**ADDENDUM #02**

**PROJECT #:** 2015-093

**PROJECT NAME:** Culvers's Restaurant Re-Image

840 W. Sunset Drive

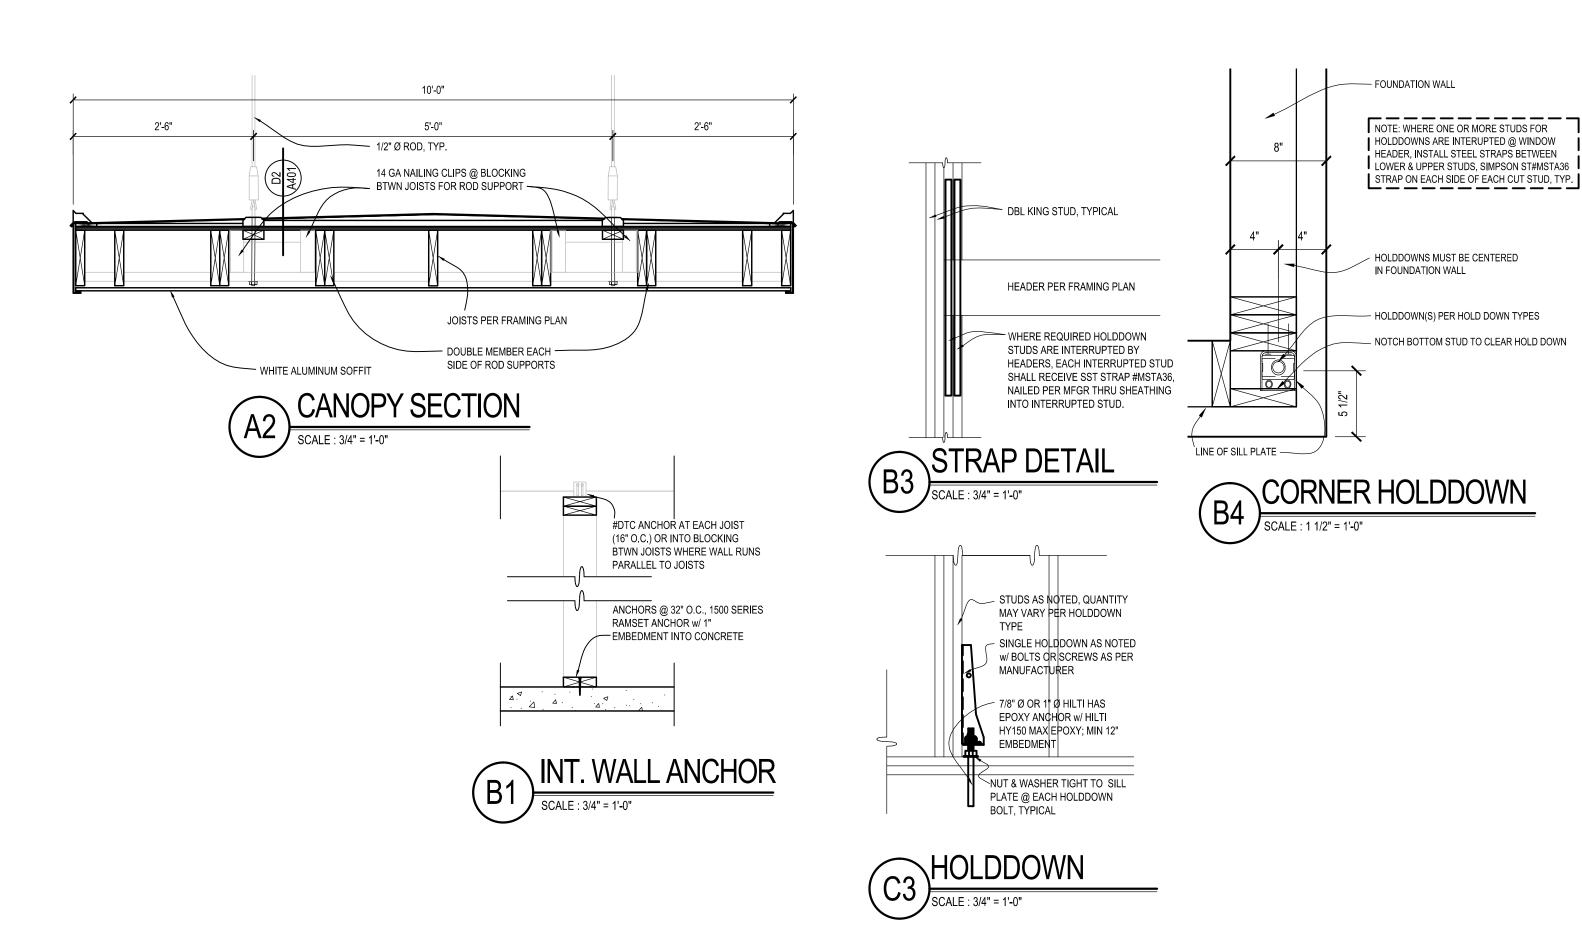
- 1. B7/S102: Add (3) 2x12 under roof parapet kickers (2 locations).
- 2. **B5/A100:** Rework existing guardrail at drive thru entrance as needed for new work.

- 3. Sheet A101:
  - a. **E5:** Add stone from Drive thru entrance around to existing toilet room per elevations.
  - b. **H5:** Add stone corner.
- **4. E5/A104:** Add Slope roof to back of parapet at various locations.

- 5. Sheet A201:
  - a. **B2 and C5:** Existing RTUs were added to elevation per City's comments.
  - b. **B5 and F5:** 
    - i. Increased parapet height by 2'-6" VIF to screen roof top units.

- **ii.** Add stone corners and wainscot from existing toilet room around to the drive thru entrance.
- 6. Sheet A202:
  - a. **B2 and C5:** Existing RTUs was added to elevation per City's comments.

- b. **B5 and F5:** 
    - i. Increased parapet height by 2'-6" VIF to screen roof top units.
    - **ii.** Add stone corners and wainscot from existing toilet room around to the drive thru entrance.

- c. **H7:** Section was increased to show the existing RTUs.

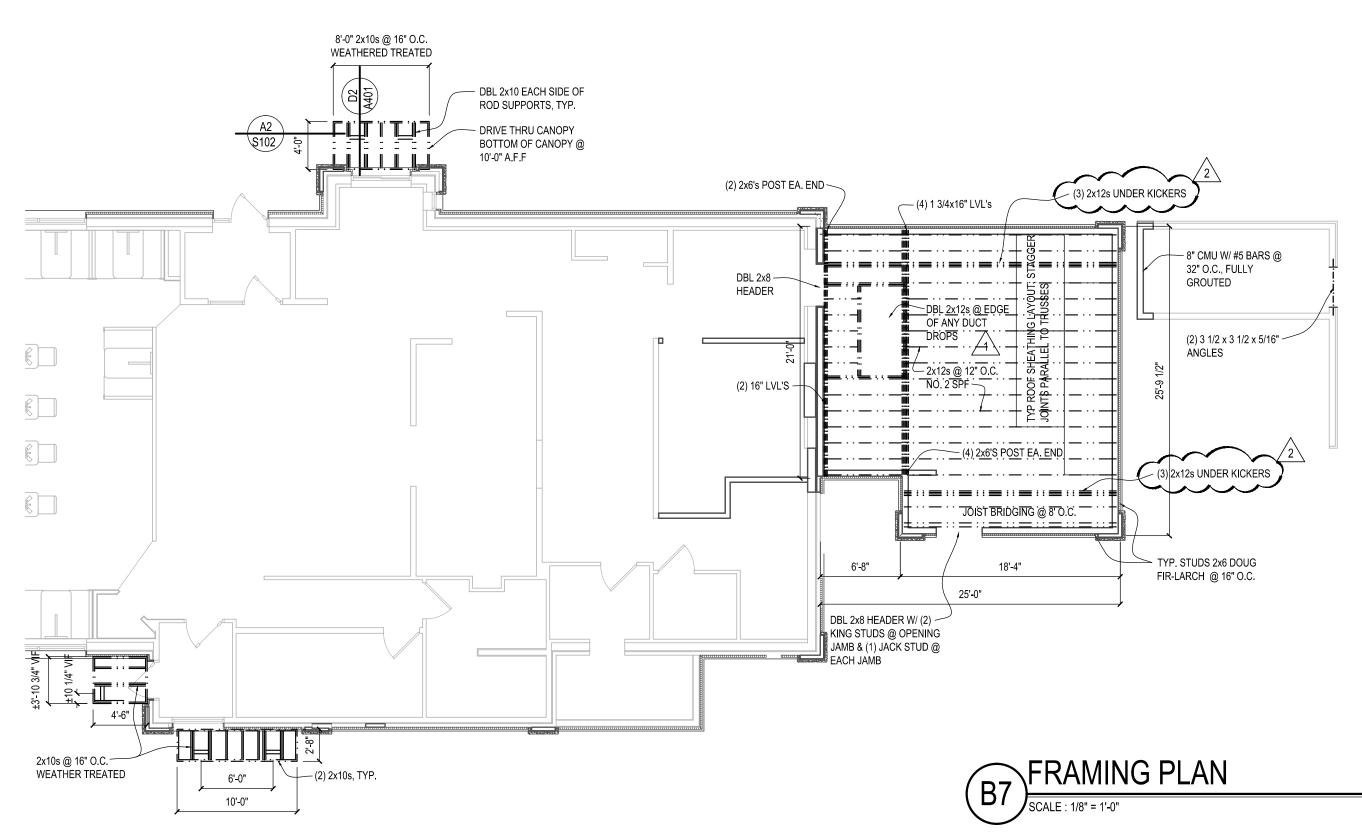
**7. Sheet A401:** Increase the parapet height for all wall sections and details. Roof membrane to extend up and over wall as shown.
